TRUCK, DUMP, HEAVY, MC3 (MACK)
TRUCK, DUMP, WITH WINCH, HEAVY, MC3 (MACK)
CO-AXIAL CAPACITOR - CAB HEATER BLOWER MOTOR

MODIFICATION INSTRUCTION

1. This instruction details the fitting of a co-axial capacitor to the cab heater blower motor to improve RFI suppression.

FIG 1 - MOUNTING OF CO-AXIAL CAPACITOR

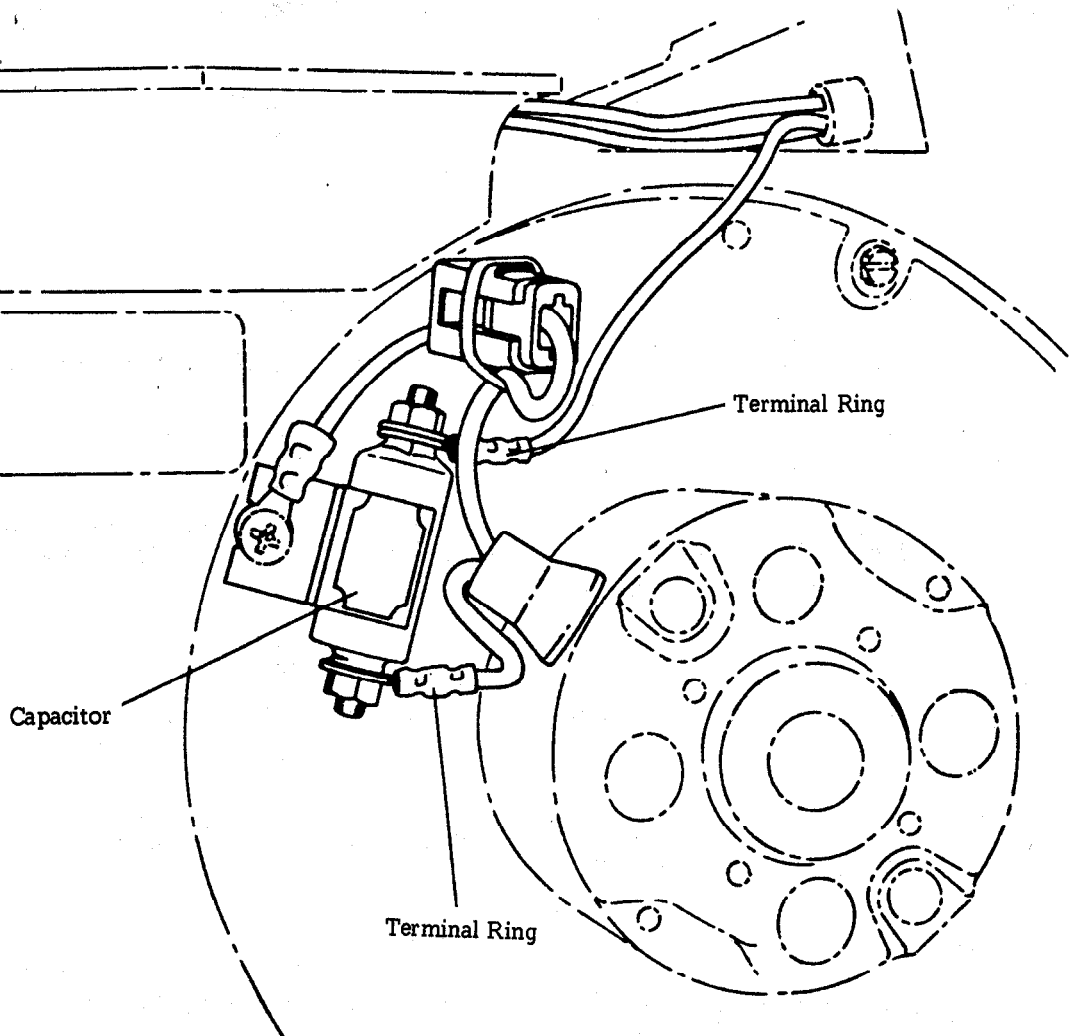
8. To carry out the modification, proceed as follows:
- Trim 10 mm off the end of the capacitor, item 1 from Table 1, mounting tail
 - Cut the power connector from the power lead and discard it.
 - Crimp suitable 3/16 inch terminal rings to the ends of the power lead, as illustrated in Fig 1, and fit the leads to the capacitor.
 - Loosen the screw on the heater body holding the earth lead and mount the capacitor as illustrated.
